SUBJECT : Hyundai ImageQuest Co., Ltd.
FCC ID: PJIL15A0C063
Class II Permissive Change
Orig. Grant Date: March 11, 2003

Transmitted herewith, on behalf of Hyundai ImageQuest Co., Ltd. is an application for a Class II Permissive Change Certification of the following 15-inch LCD Monitor:

FCC ID : PJIL15A0C063
Model/Type : L52S/L15A0C063

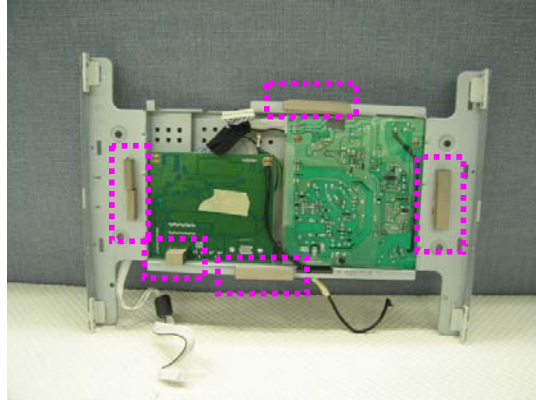
1. Attach a gasket on the main frame and main board to contact the lcd panel

2. Apply ferrite core to OSD signal line
